The Barn and 40 Shed Section D - D as proposed
1 : 100

The Barn and 40 Shed Section E - E as proposed
1 : 100

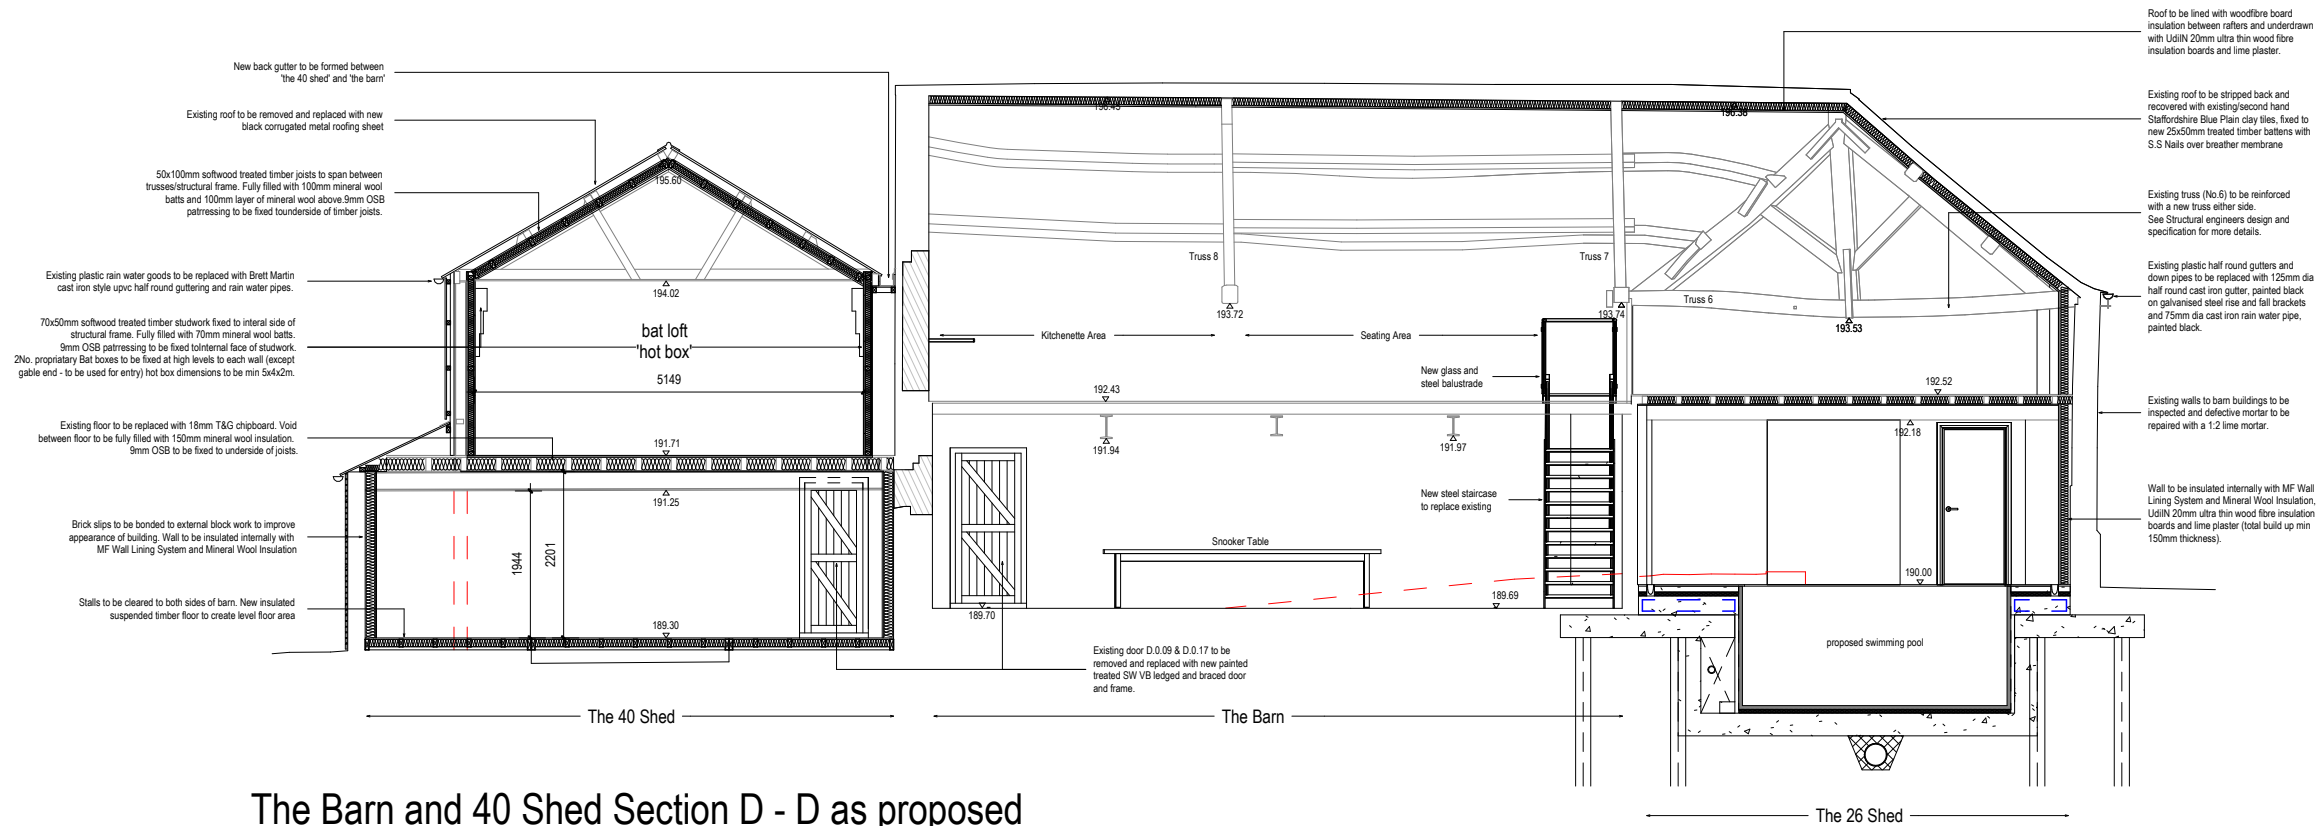
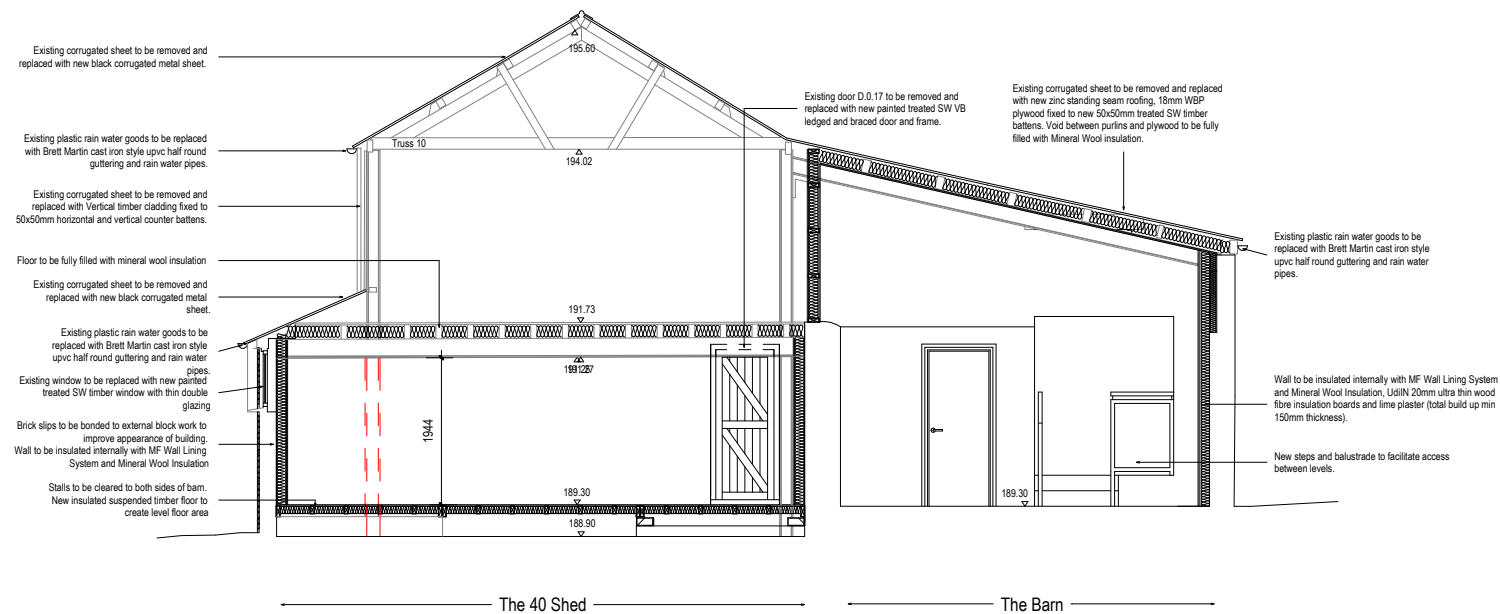
B	17/12/21	AM	Amendments to height of Bat Box following consultation with Ecologist
A	14/12/21	AM	Minor amendments to internal layout following consultation with client
Rev	Date	Drawn	Description
